**APPLICATION FOR SHORELINE SETBACK VARIANCE  
AND  
FINAL ENVIRONMENTAL ASSESSMENT**

**After-the-Fact Approval of Seawall Reconstruction**  
68-701 Crozier Drive, Mokuleia, Oahu, HI  
TMK (1) 6-8-006:018 & 019

**COMMENT LETTERS AND RESPONSES**

Figure 2  
Topographic Survey of TMK 6-8-06:18 & 19

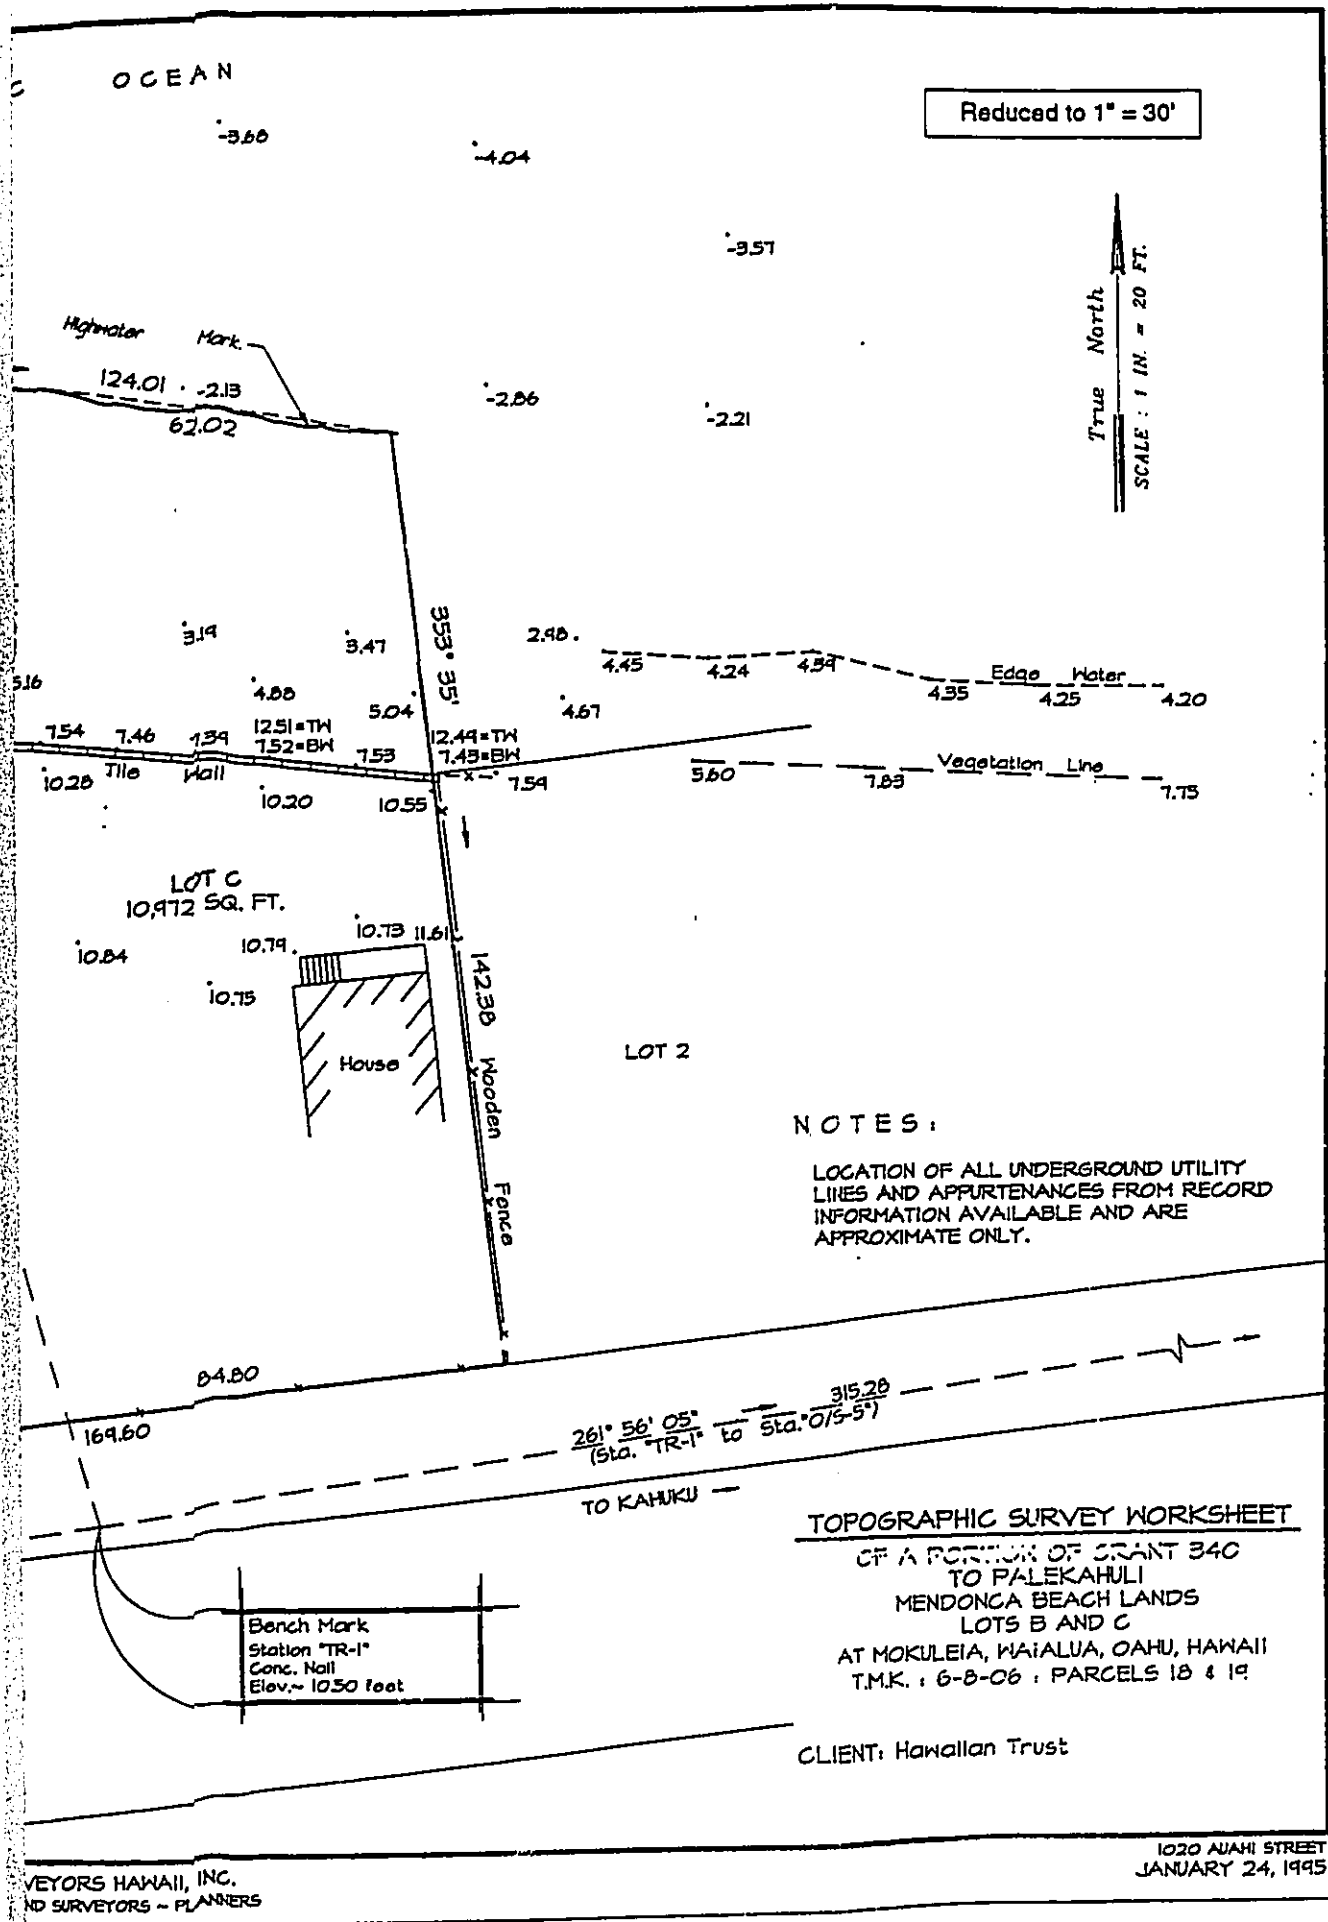
Exhibit A, the Shoreline Survey Map, defines two separate shorelines: one along what is referred to as a "highwater mark" and one following along the toe of the wall. This map apparently has been taken as the basis of Figure 2, "Topographic Survey of TMK 6-8-06:18 & 19," which includes a third shoreline marking labeled "Edge water" appearing on adjacent parcels. The presentation of these three somewhat ambiguous shorelines is confusing.

boundaries, particularly along coastlines which fluctuate over variable intervals, is not fully settled, although it has been extensively addressed by the Hawaii State Supreme Court [e.g., Ashford, 50 Haw 314 (1968); Sotomura, 55 Haw 176 (1973); and Sanborn, 57 Haw 585 (1977).] The delineation in Figure 2 of the boundary along the highwater mark presumably reflects a prior shoreline, since it appears considerably makai of the "edge water" lines drawn along adjacent parcels. In view of definitive relevance of the water's edge to boundary determinations, it would be helpful to resolve the shoreline ambiguities which this figure contains.

**Shoreline Survey.** We understand the confusion regarding the edge of water labels in Figure 2, which is a topographic survey worksheet prepared by Engineers Surveyors Hawaii, Inc.. The State uses the certified highwater mark as a regulatory line for setback purposes. In this case, the Certified Shoreline is found at the makai toe of the reconstructed seawall. Even though the seaward portions of these lots are underwater, it is accurate and proper for the surveyor to show on their maps the recorded seaward boundary of the property as documented at the Bureau of Conveyances. The current edge of water on these lots corresponds with the lines shown for the adjoining properties.
